AMENDMENT 1

**Information technology – Implementation and operation of customer premises cabling –
Part 3: Testing of optical fibre cabling**

Amendment 1 to International Standard ISO/IEC 14763-3 was prepared by subcommittee 25: Interconnection of information technology equipment, of ISO/IEC joint technical committee 1: Information technology.

Figure 8 – Channel and permanent link test configuration

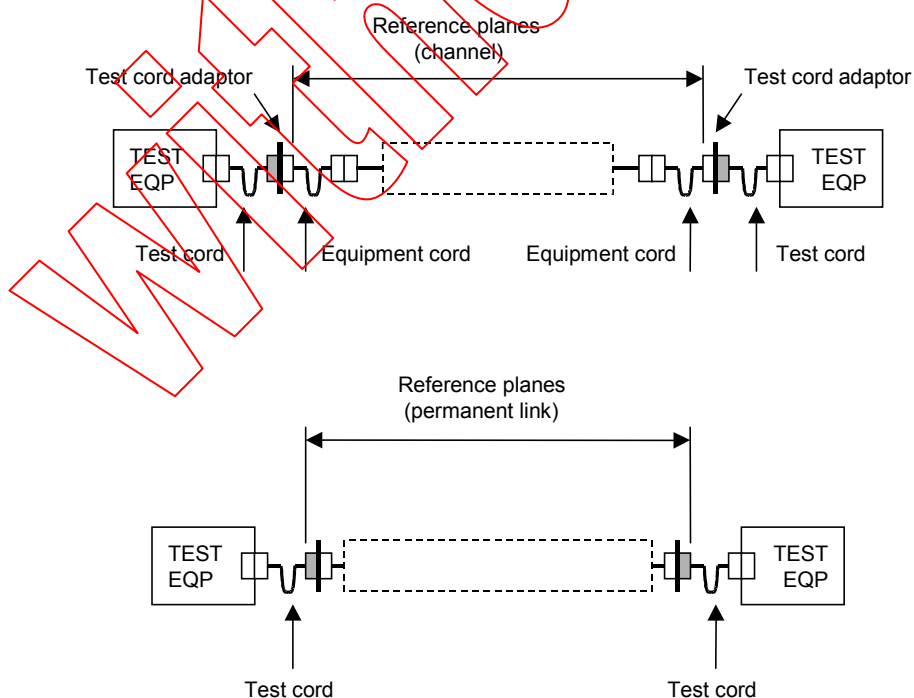
Replace the existing Figure 8 by the following new Figure 8:

NOTE The dotted area contains cable and may contain splices and additional connections.

The test configuration reference planes of a channel are within the equipment cords next to, but excluding, the connections of the equipment cords into the test cords (see Figure 8). The test configuration reference planes of a permanent link are within the test cords next to, and including, the test cord connections which mate to the termination points of the permanent link under test (see Figure 8).
